City of Tukwila

Planning Commission
Public Hearing Agenda
August 27, 2009 - 7:00 PM
Tukwila City Hall Council Chambers

To: Planning Commission
From: Rebecca Fox, DCD
Subj: L08-082—Urban Renewal Overlay District—
Supplemental Information Memo for August 27, 2009 Meeting
Date: August 20, 2009

Option 1

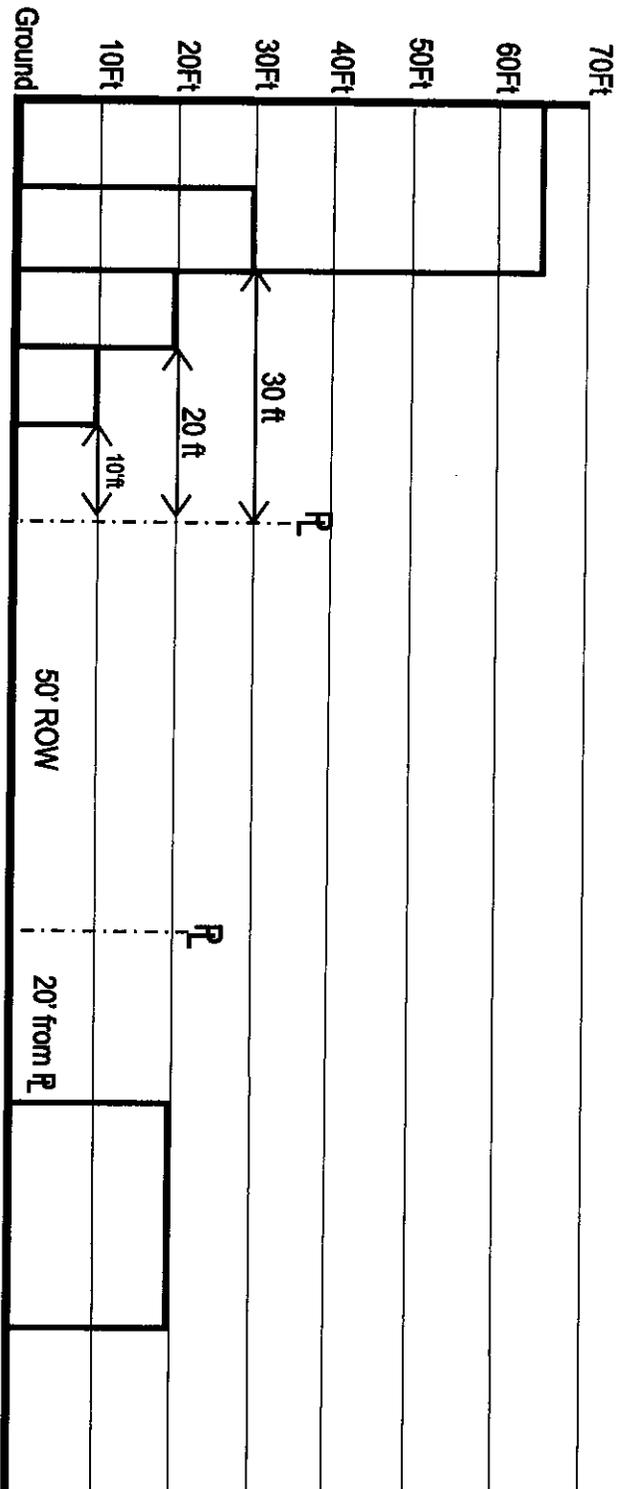
The proposal would require that any individual sides of buildings that faced LDR zones would be tiered back at set intervals for specific floors (i.e. 10' setback for the first floor, 20' setback for the second floor, and 30' setback for the third floor.) There would be no difference in setback requirements whether the front, second front, side or rear yard was adjacent to LDR. Setbacks would be attained by tiering the structure at specific floors up to the third floor at 30'. There would be no additional setback for floors four through six.

Pro: The tiered building setbacks help to further buffer residential areas from impacts of proposed development. Requirements for tiered buildings afford additional visual separation between potential buildings and existing LDR zones. Bringing the building tier closer to the street provides a presence for pedestrian interest, and is in scale with residential development. The option provides certainty by prescribing a specific tiered style of building, with fixed setback distances for individual floors.

Con: Requiring specific building tiers/upper floor setbacks limits flexibility for building design and site planning options. Requiring building tiers at specific points will increase building costs and system complexity, and will be a detriment to maximizing rentable space. (Attachment E, Tarragon Development) Requiring two tiers is unduly restrictive since the Tukwila International Boulevard Design Manual already provides design criteria meant to reduce the apparent scale of large commercial buildings located adjacent to residential districts.

Increased setbacks reduce developable land, and economic incentives for development. This may be an impediment to the City's reaching its redevelopment goals. Larger setbacks tend to maintain the more suburban feel, and lessen the desired compact center urban look and feel that is the goal in the Urban Renewal Overlay District.

Option 2

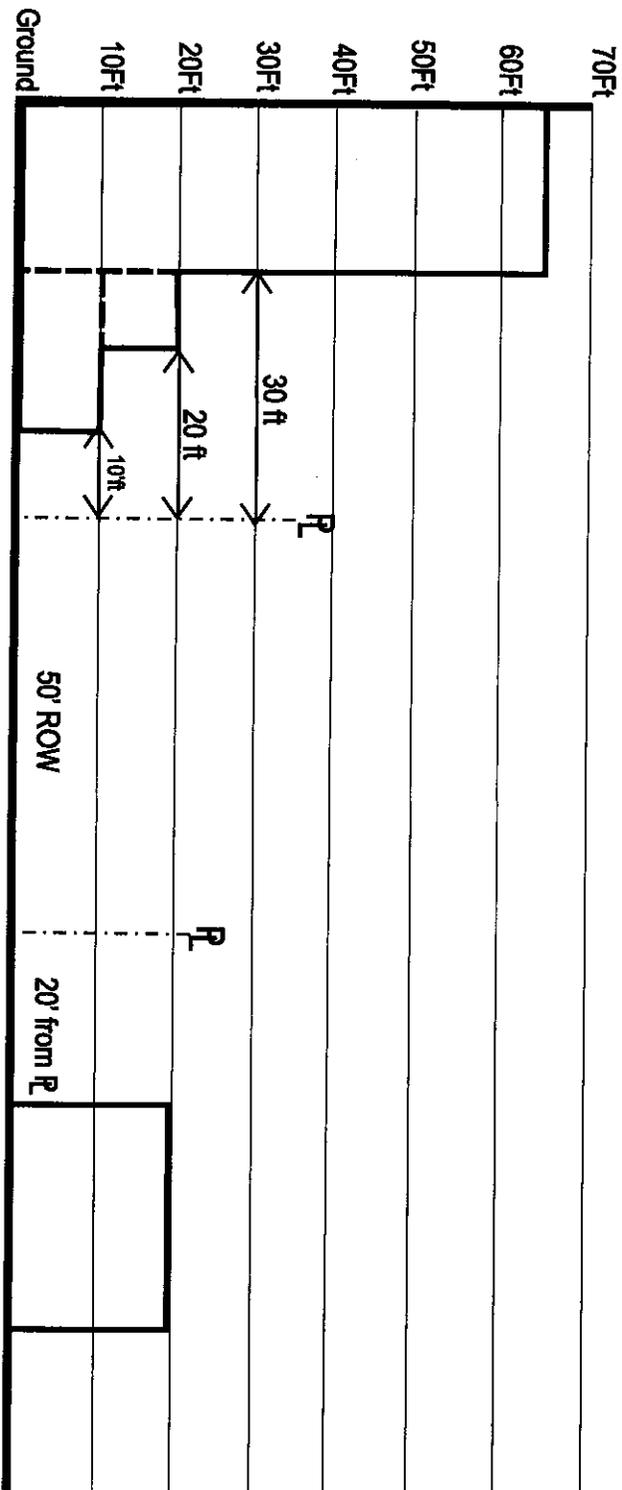
This alternative extends the maximum setback to 30' in the vicinity of LDR. Rather than relying on the 1:5 to 1 ratio set out in the Neighborhood Commercial Center (NCC) zone, this option sets out minimum setbacks of 10', 20' feet for the first and second floors. The maximum setback for the third floor and higher is 30'. These standards apply equally for all sides, including the front, second front, sides and rear. Depending on the building design and site plan, this could be accomplished either through tiering the building at individual floors, by using a combination of tiers and setbacks, or by setting the entire building back up to a maximum of 30'. This flexibility is similar to what is allowed under current NCC zoning. See chart (Attachment C) and graphic (Attachment F)

Pro: This option could offer greatest flexibility to encourage future redevelopment, while affording protection to single-family residences. It allows developers and architects the ability to meet setbacks either by placing the entire building back, by providing one or two tiers and setting back the remainder of the floors, or by building a combination of tiers and setbacks to meet the desired uses. The flexibility provides somewhat of a transition between suburban and more urban-style development in proximity to single-family homes. Depending on the style of building and the site plan, a tiered building could sit within 10' of the property line for pedestrian interest, or a building without tiers could be set back 30' for a more open feeling.

Con: This option could possibly result in a series of tall buildings set back the maximum distance across from LDR. This is unlikely since building designs would come before the Board of Architectural Review for approval. In addition, the Tukwila International Boulevard Design Manual provides guidelines for building design to reduce the apparent scale of buildings located adjacent to residential districts through such features as modulation or distinctive roofline. The possibility of setting the entire building back

could allow parking lots being placed in front of buildings, and lessen the compact center feel that is desired for this area. Setting the entire building back would also tend to lessen pedestrian interest.

Option 3

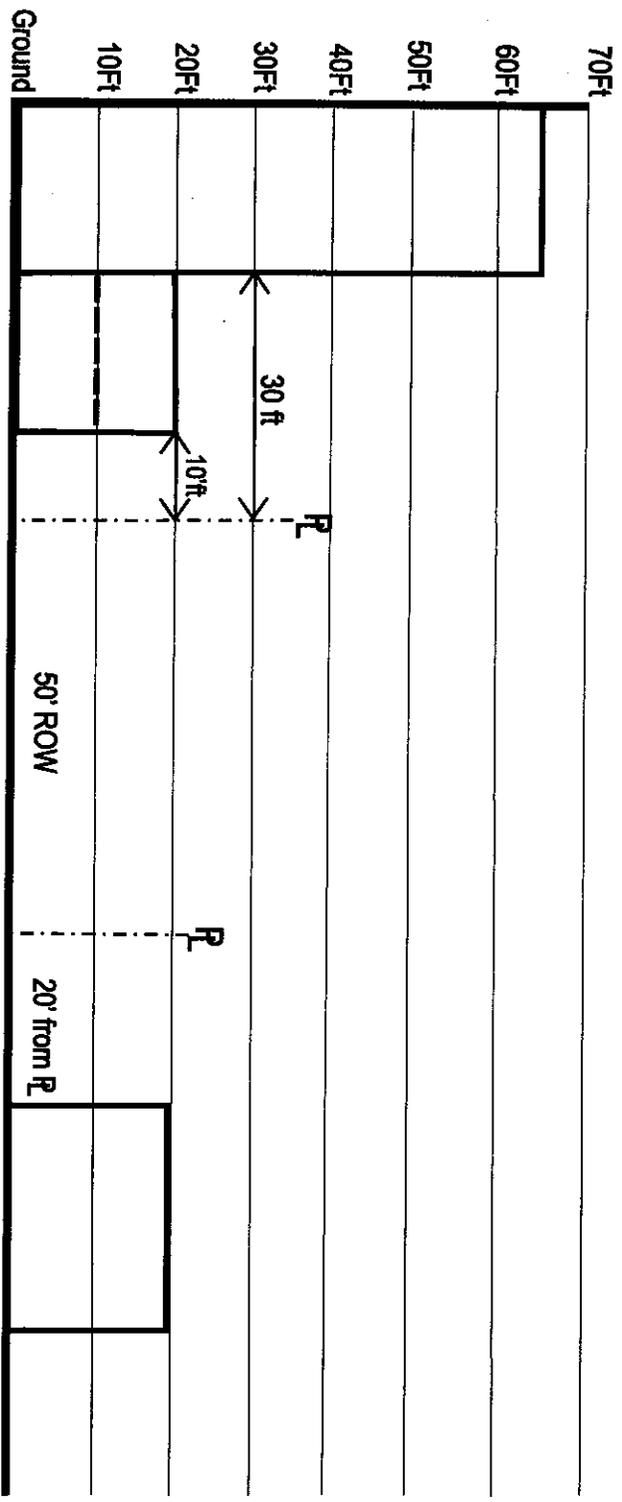
Option 3 combines features of options 1 and 2 by requiring one tier-back with a minimum setback of 10' for the first two floors, and a maximum total building setback of 30' for all floors above two floors. Flexibility is provided to decide whether the tier will be one or two floors tall. See chart (Attachment C) and graphic (Attachment G)

Pro: The visual impact on residential uses is limited by allowing a one or two story tier, which no greater in height than a single-family home. The greatest bulk and height of the building is set back 30'. Allowing a two-story tier within ten feet of the property line moves Tukwila closer to a more urban feel, as desired. The pedestrian environment is enhanced by the certainty of locating buildings closer to the "build to" line. Requiring only one tier of one or two stories in height limits the negative effects of tieres on building systems. Although a tier is required, greater design flexibility is maintained, by providing the developer the choice to construct either a one- or two-story tier. A two-story tier might be especially suitable for live-work space. Impacts on developable space, and negative impacts on building systems, though present, are lessened. With a required tier, the possibility of a "wall" of buildings is avoided.

Con: Requiring a tier imposes limits on developable space and design options. Modulation and visual breaks can be provided adequately without this requirement by utilizing the guidelines developed in the Tukwila International Boulevard Design Manual.

Staff recommends Option 3 as this provides a reasonable scale tier to limit the visual impact of a tall structure, yet does not unduly limit developable space. By moving development closer to the street, it increases pedestrian interest and creates a more urban feel.

Studio Unit Example 'A'

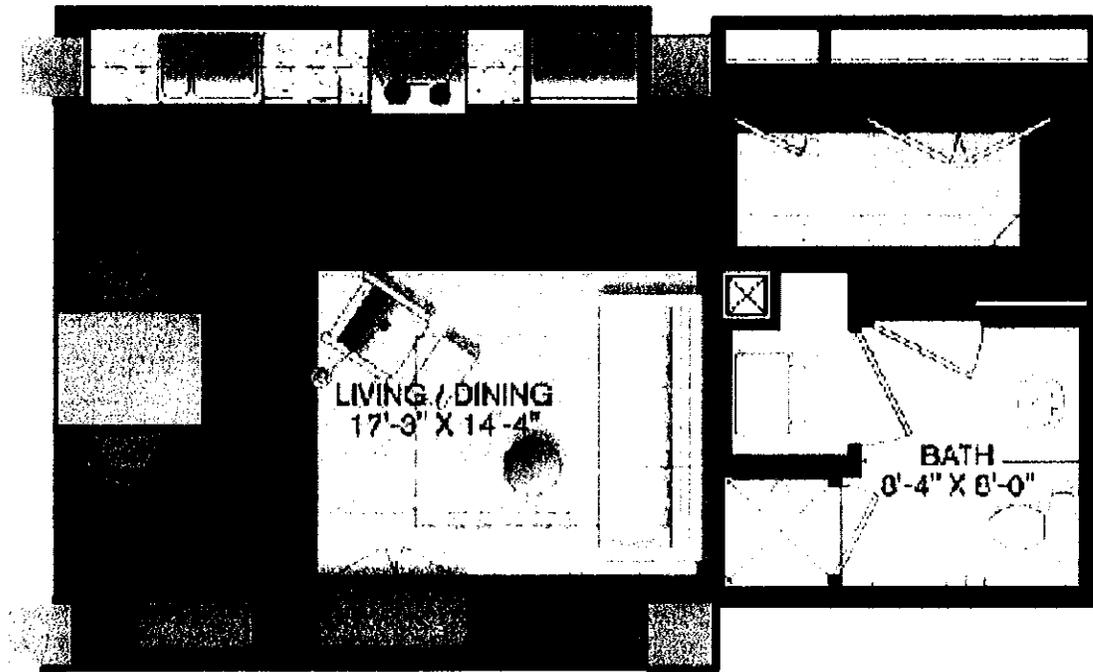
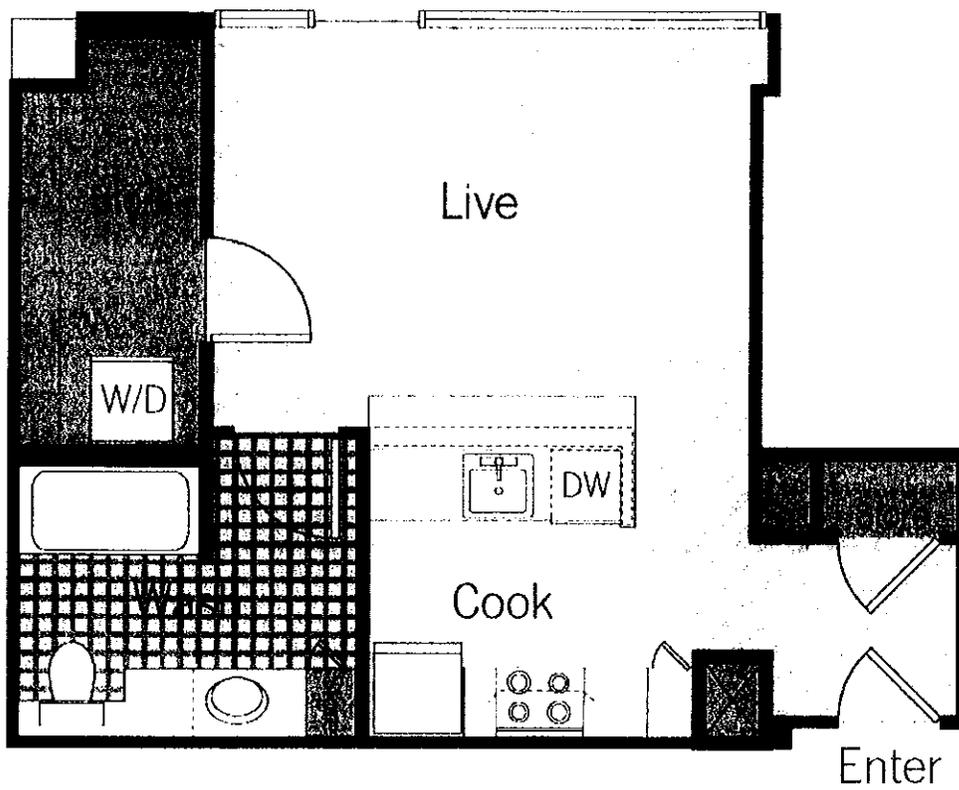
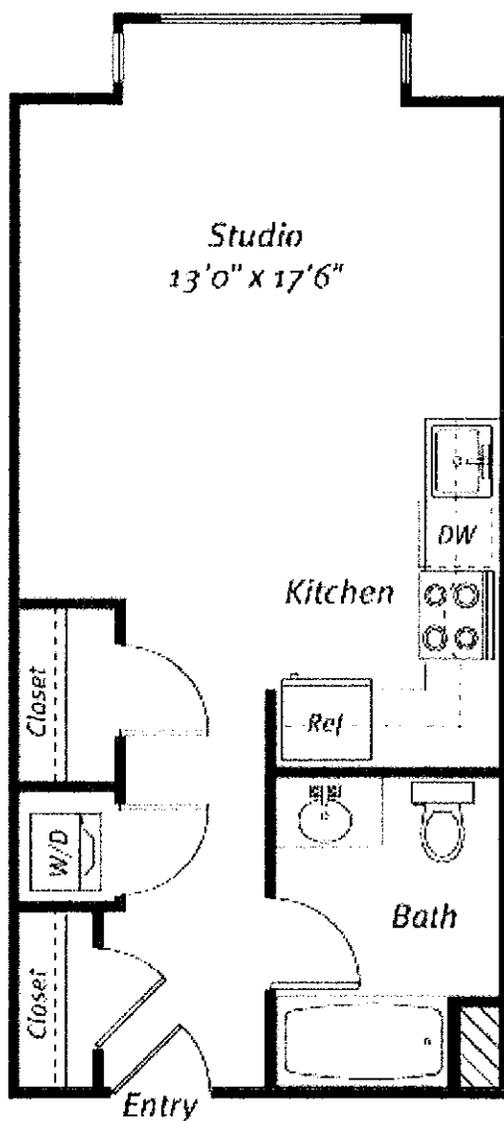
Regarding the proposed limit on unit size, we support a minimum square footage of 450sf (rather than 500). The same reasoning from above applies, but we have also included several unit examples as attachments to this letter. These floor plans illustrate how a typical studio unit might be laid out, and they are good examples of the types of studios that could be incorporated into Tukwila Village. It is our understanding that the Tukwila International Boulevard Action Committee also supports the 450sf minimum so long as the average studio size equals 500sf or greater.

While our previous recommendation was 400sf, the unit examples provided are within the 450-500sf range, and we felt that 450 should be suggested as a reasonable alternative. A difference of 50sf may not seem significant, but it plays into the overall performance and success of the development. One point of clarification would be to confirm the approved method for measuring areas. Unit area lines are often drawn with different standards depending on how the area number is to be used. For example, cost calculations may require inclusion of the exterior wall area. In the case of determining a unit's rentable square footage, other standards may be applicable, and we would like to confirm this with the City.

Staff's initial recommendation supported studio units with minimum size not smaller than 500 s.f. Tarragon Development Company initially requested minimum units of 400 s.f. , but now supports a minimum square footage of 450 s.f. (Attachment I) At their meeting on August 11, 2009, the Tukwila International Boulevard Action Committee (TIBAC) recommended a compromise alternative whereby the average size of studio units in a development would be not less than 500 s.f. with no unit smaller than 450 s.f. Staff agrees with this approach, as ensures that the community will not have too many small units, and also allows developers market flexibility.
